<p>“THIS MEDIA SHOULD NOT BE CONSIDERED A CERTIFIED DOCUMENT.”</p>	<p>MISSOURI HIGHWAYS AND TRANSPORTATION COMMISSION 105 W. CAPITOL AVE. JEFFERSON CITY, MO 65101 Phone (888) 275-6636</p>
	<p>If a seal is present on this sheet, JSP's has been electronically sealed and dated.</p>
	<p>JOB NO. J5S2186 Boone County, MO Date Prepared: 5/13/2014</p>
	<p>Addendum No. R001</p>

JOB SPECIAL PROVISIONS (BRIDGE)

SECTION THRU GRS-IBS

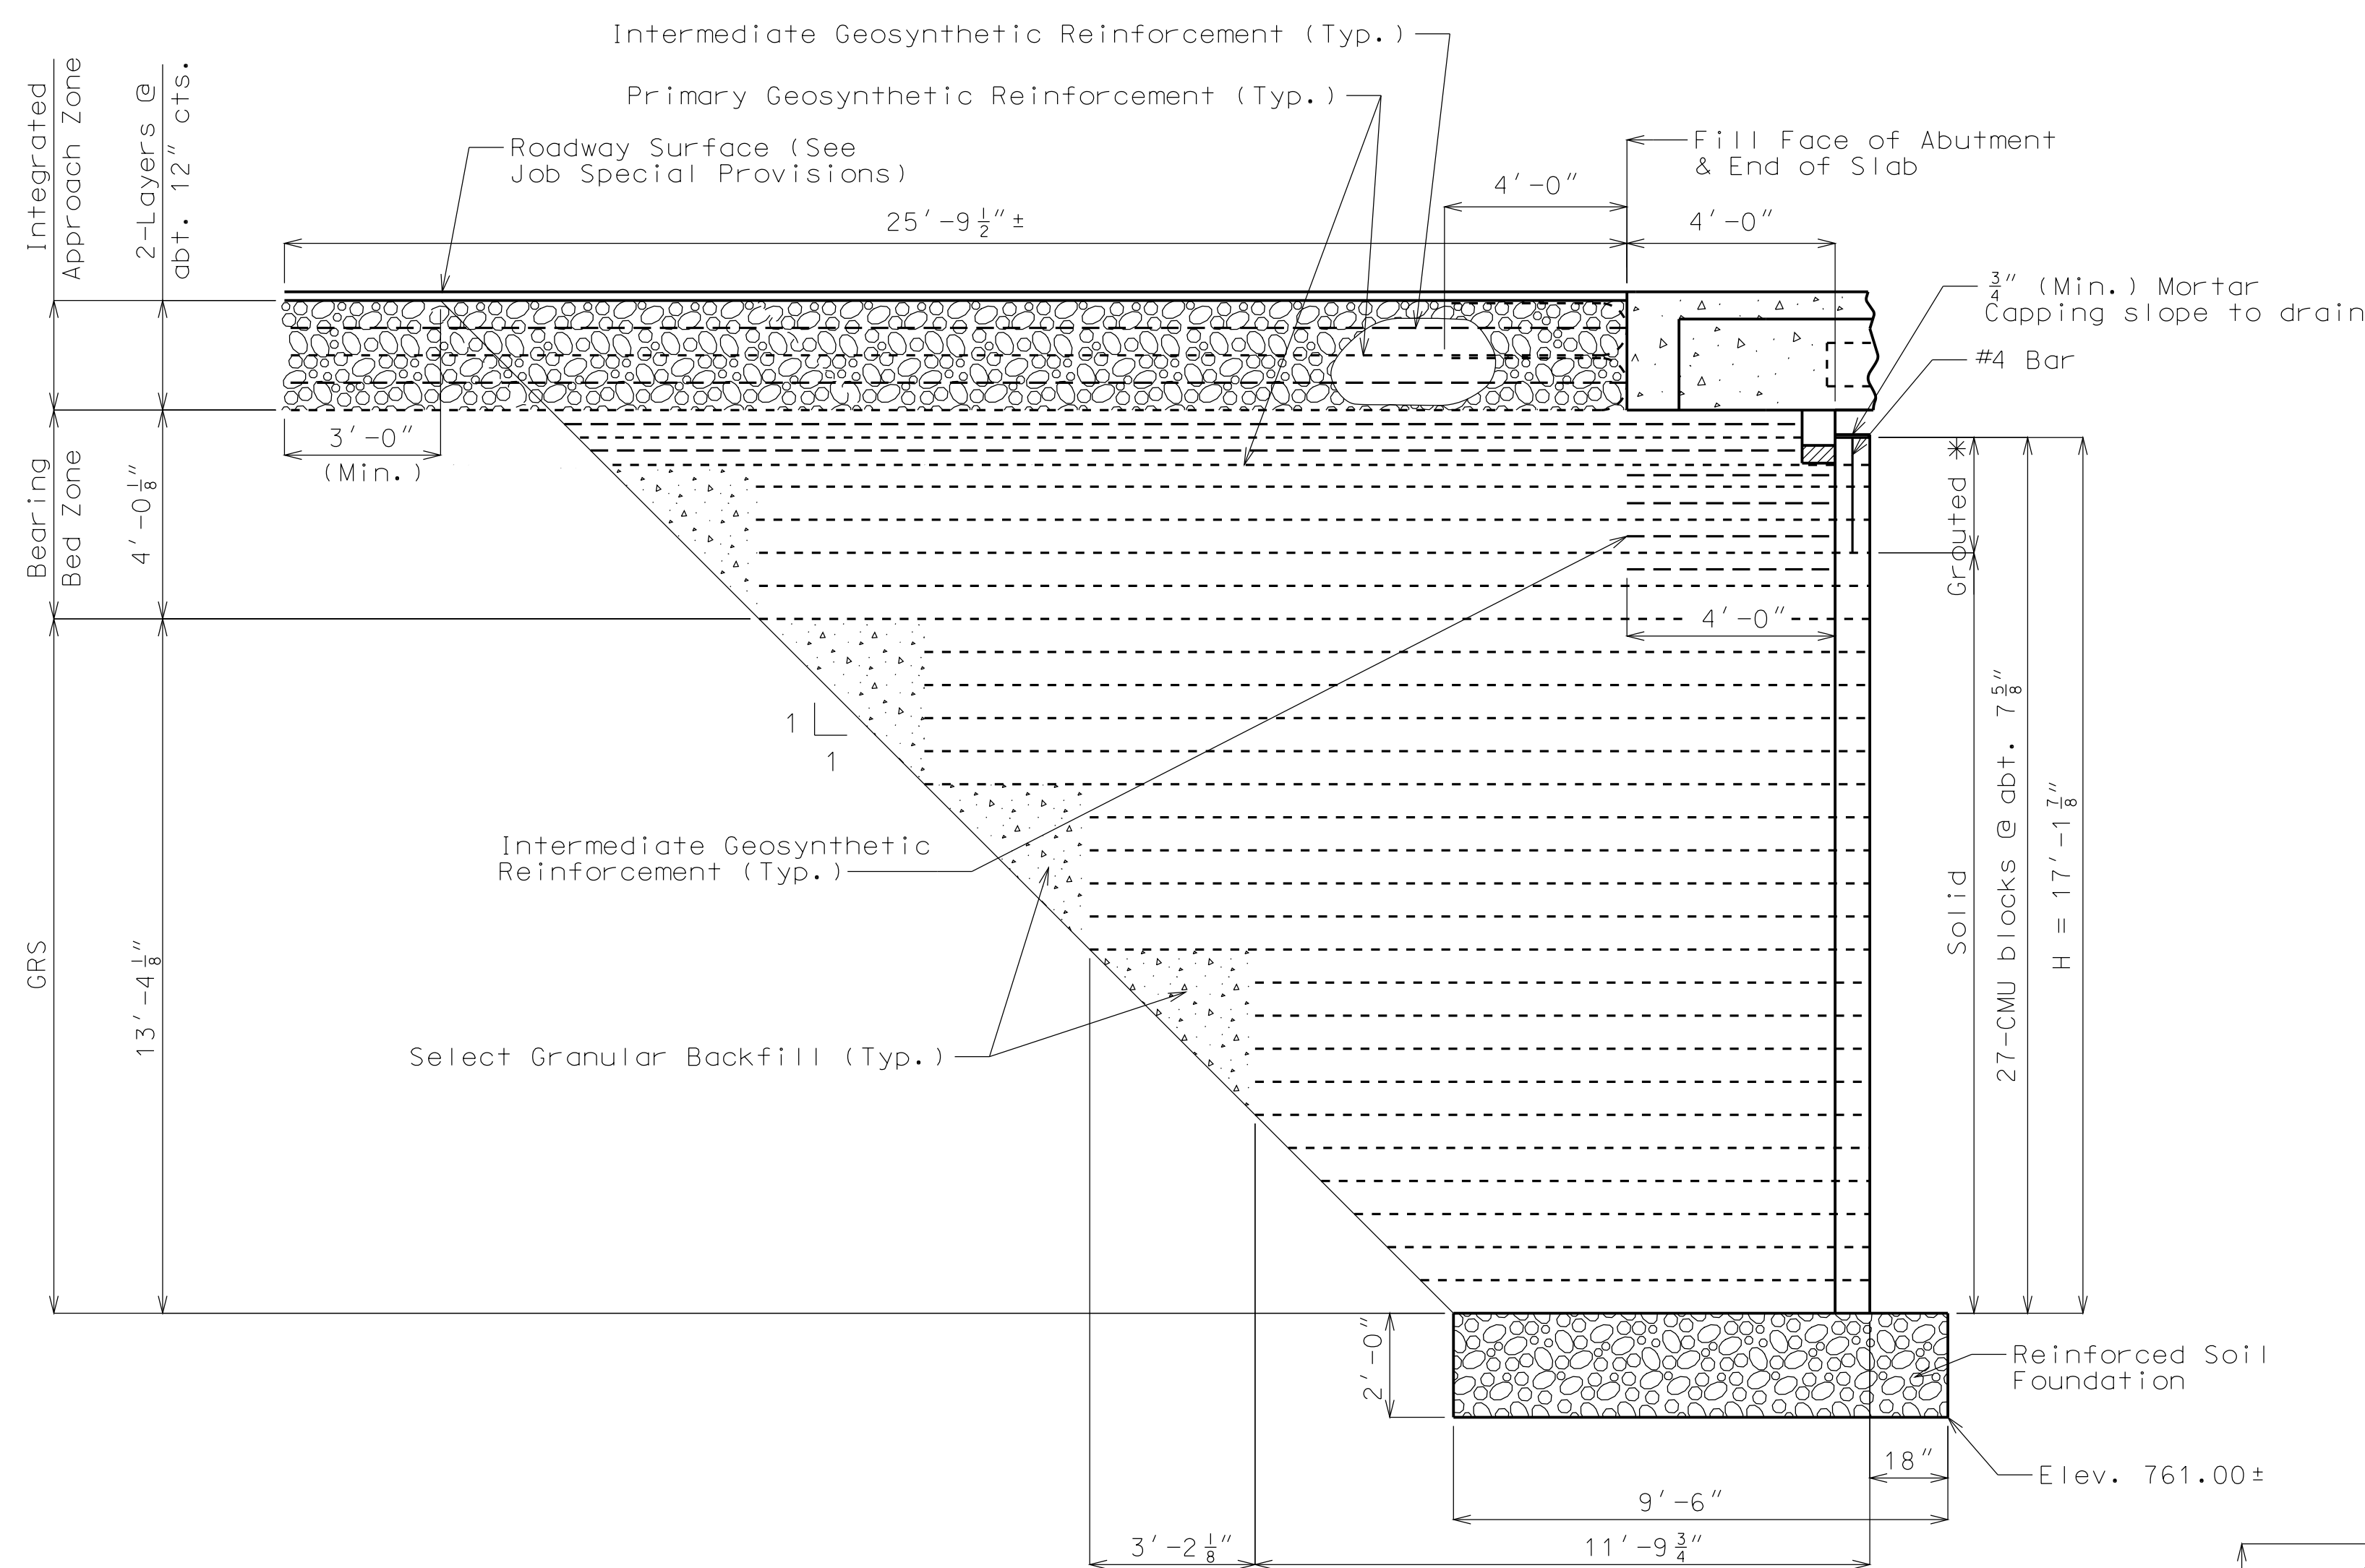
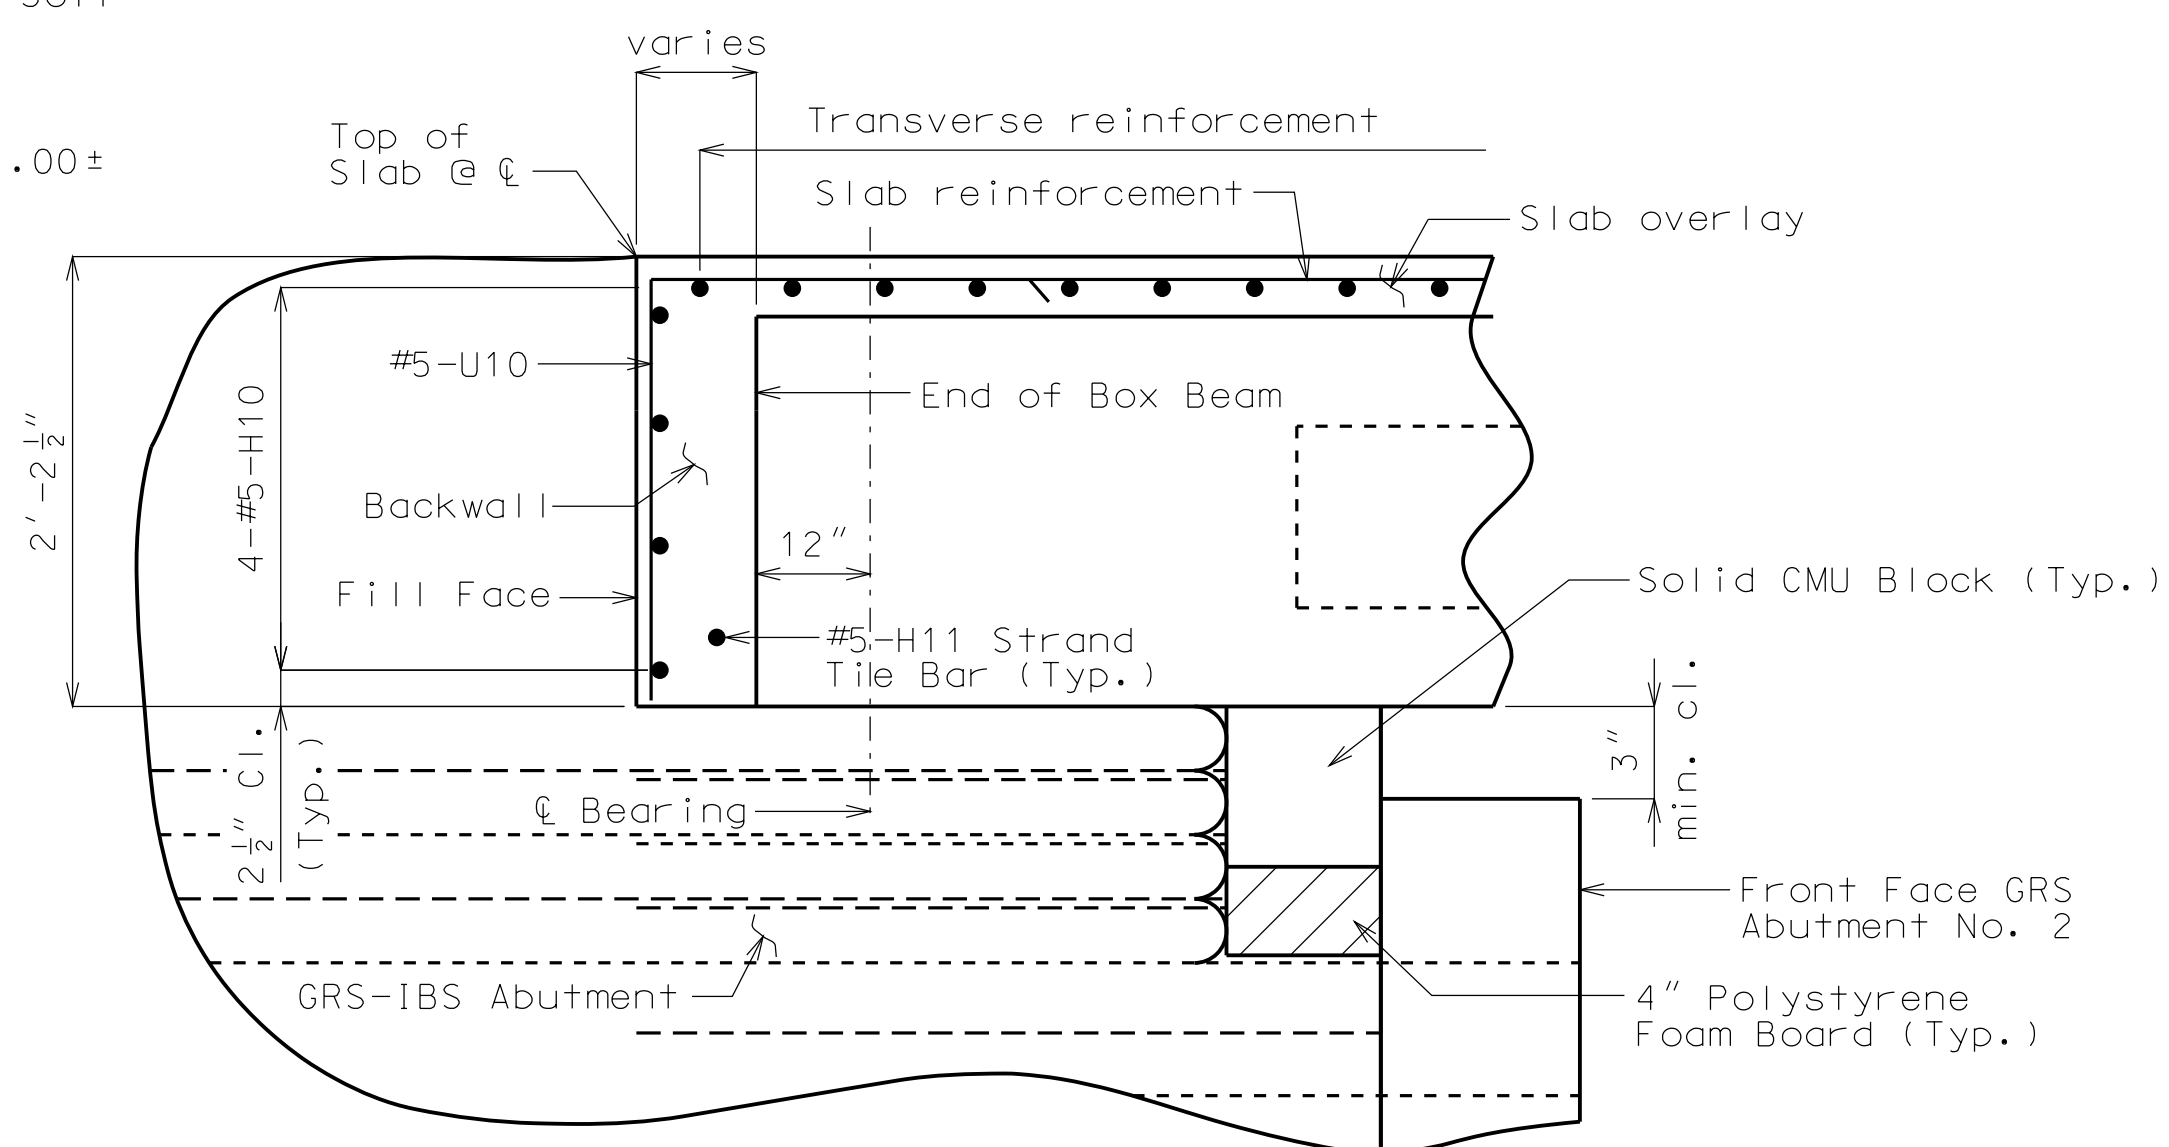
Added 5/13/14
